MASTER DEVELOPMENT PLAN

SINCLAIR TRACT

Re: Sinclair Tract **MDP # 032-06**

The City Staff Development Review Committee has reviewed the Sinclair Tract Master Development Plan **M.D.P. # 032-06**. Please find enclosed a signed copy for your files. Your plan was approved for acceptance; however please note the following conditions:

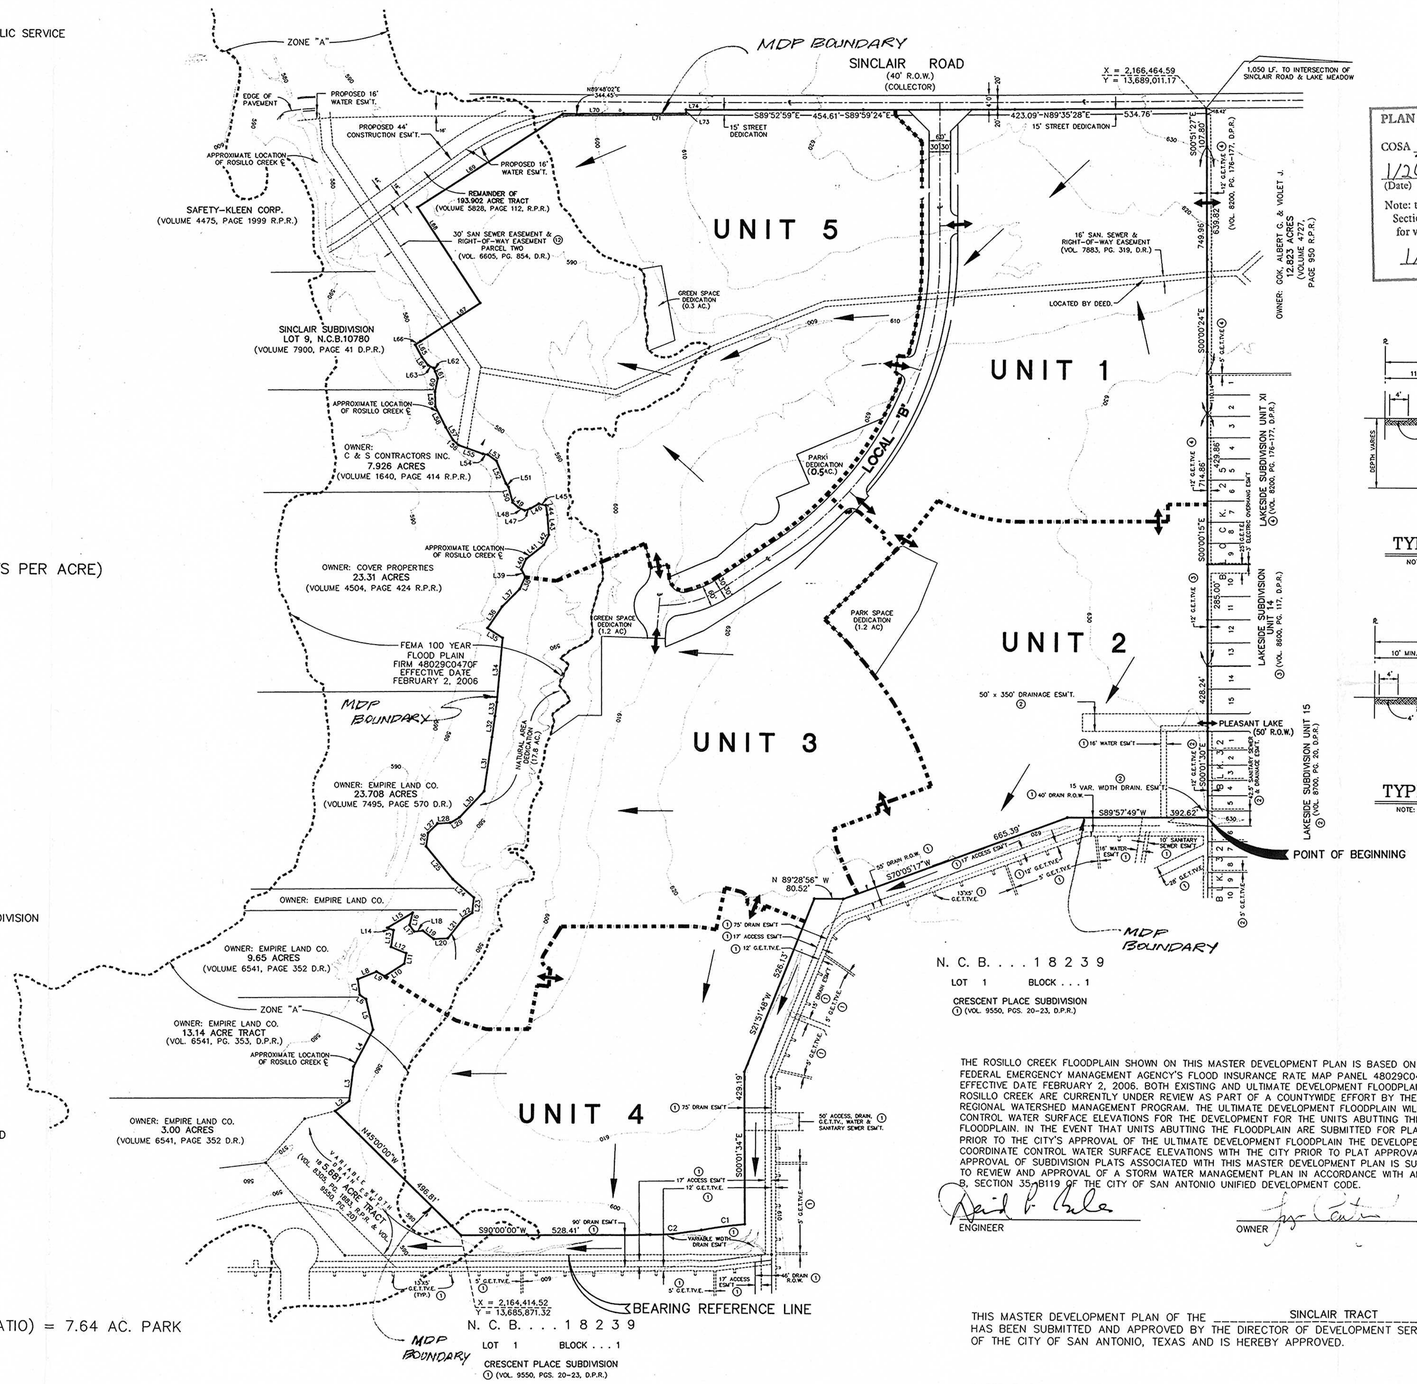
In consideration of public safety and convenience, excessive grades by reason of topography should be avoided in street layouts and arrangements. Any access and R.O.W. issues along state facilities will need to be resolved with the **Texas Department of Transportation (TXDOT)**. For information about these requirements you can contact TXDOT at 615-5814.

- UDC 35-502 (a) roadways.
- UDC 35-506 (q) sidewalks.
- All access shall provide clear sight distance.
- Left and right turn deceleration lanes will be required at the main entrance at time of platting.

It should be understood that this is a general review of a conceptual plan not an in-depth review of internal and external traffic flow, or streets and drainage plans. The internal street network shall be planned in order to provide safe and efficient movement of traffic to and from, within and past, the proposed development, while minimizing the impact to non-site trips. All technical requirements of the Unified Development Code will be complied with at the time of platting

- The parkland provided shall be shown as "Park" or "Open Space" on a plat; UDC section 35-503(e) *Designation of Parkland.*
- The parkland provided is dedicated to the Homeowners Association.
- The instruments creating the Homeowners Association are provided by the second application for plat approval; UDC section 35-503(e) *Designation of Parkland.*
- Parkland dedication, including open play area, shall be platted by the second phase of residential development; UDC section 35-503 (f) *Development Phasing.*
- All amenities provided shall comply with standards and specifications found in UDC section 35-503(h) *Credit Park Facilities* and Table 503-4 if any credit is to be awarded.

- The Texas Sites Atlas indicates that no archaeological sites have been previously identified within the above referenced property. However, the project area is adjacent to Rosillo Creek and there is a **high probability** that the property may contain sites, some of which may be significant. In particular, the project area is within possible proximity of the **Battle of Rosillo Creek fought in 1813**. Thus, before any work that might affect any sites is begun, a qualified professional should conduct an archaeological investigation of the property.

The property must be platted in accordance to the UDC and the Major Thoroughfare Plan to reflect the approved MDP. It is suggested to work closely with the school district, so they can plan accordingly.
